# City of Mississauga

### City Department and Agency Comments

Date Finalized: 2021-03-08	File(s): A108.21 Ward: 6
To: Committee of Adjustment	
From: Committee of Adjustment Coordinator	Meeting date:2021-04-08 1:00 PM

**Property Address:** 6736 Lisgar Drive

### Appendix 1 – Transportation and Works Comments

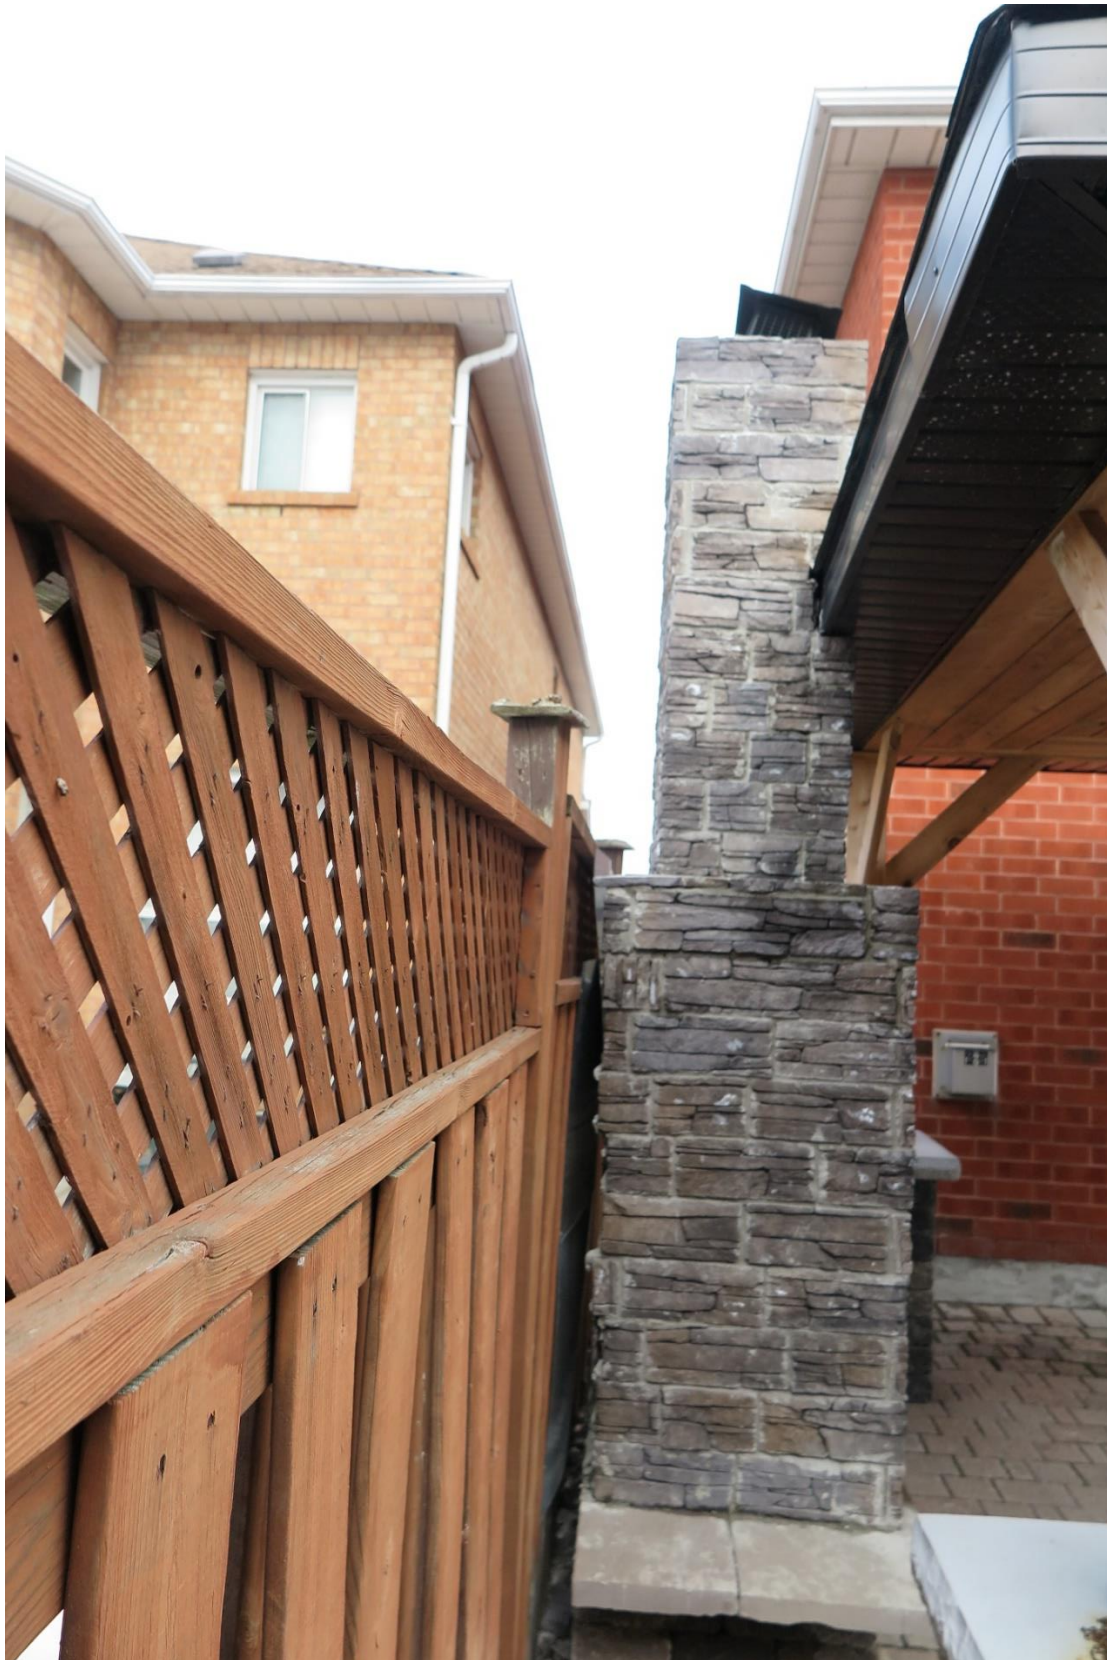
We are noting that the Grading Plan approved for this property (Grade Control Plan C-31902) depicts a split drainage pattern where the high point shown is approximately at the rear of the dwelling. This grading pattern means that any drainage from the rear of the dwelling (area where structure constructed) was intended to be directed to the rear yard and then in a southerly direction (to a catchbasin located at 3933 Worthview Place).

The accessory structure constructed does have an adequate setback from the fence to allow for a drainage swale; however, a fireplace/structure has been constructed between the accessory structure and fence which may slightly impede the minimal amount of drainage which was intended to be accommodated through this area.
